ENGINEERING CHANGE NOTICE
DART AEROSPACE LTD

Date: 13.02.22	Job No.:	ADR Yes/No: Y	ADR Date:	ECN #: 13- 534
Product No.: D119-646		Created By: DB	Approved By: <i>MP</i>	
Product Name: A119 SKIDTUBES		Checked By: <i>DB</i>

Reason for Change: Cap assembly hardware interferes with the installation of the Agusta Ground handling Wheel Kit

DART SERVICE INSTRUCTION

FIGURE 1. MODIFIED D119-646-XXX SKIDTUBE

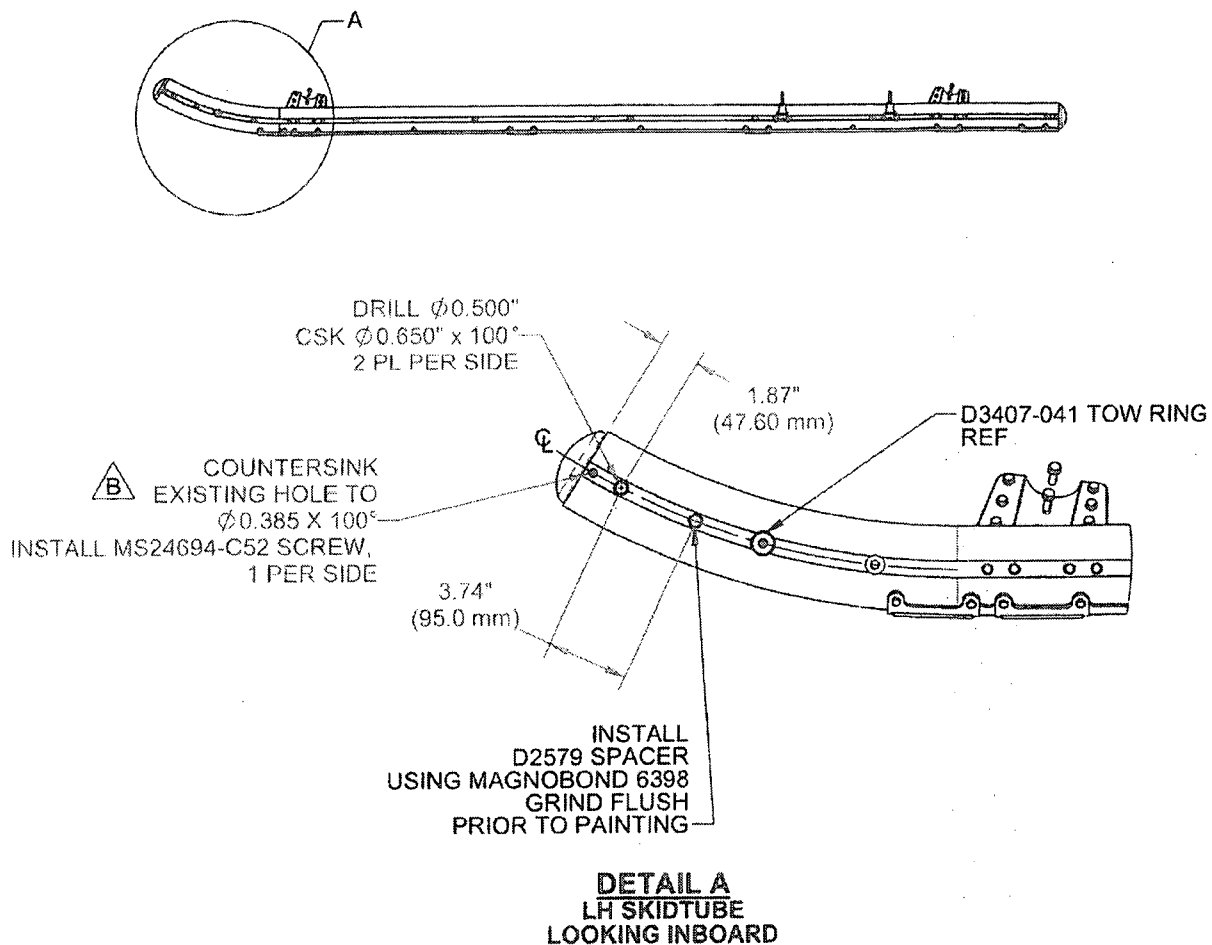
- 2.1 Rotate the D3407-041 Tow Ring to the vertical position as necessary.
- 2.2 Mark holes in the center ridge as shown in Figure 1. Drill through skidtube with $\varnothing 0.500"$ (12.7 mm drill), and countersunk to $\varnothing 0.650 \times 100^\circ$, two places per side.

- 2.3 Remove and discard the hardware retaining the forward Cap. Countersink the existing holes to $\varnothing 0.385 \times 100^\circ$.
- 2.4 Deburr holes. Touch up affected areas with chemical film material (Alodine 1200 or 1201) per MIL-C-5541.

- 2.5 Bond D2579 spacers into the $\varnothing 0.500$ holes center in the skidtube using Magnobond 6398. Grind flush prior painting as shown in Figure 1.

- 2.6 Apply one coat of MIL-P-85582 or MIL-P-2337 primer and 2-3 coats of MIL-C-83285 polyurethane coat to match original finish.
- 2.7 Fasten the forward Cap using MS24694-C52 Screws. Seal threads with Proseal 890. Ensure that screw heads sit below skidtube surface
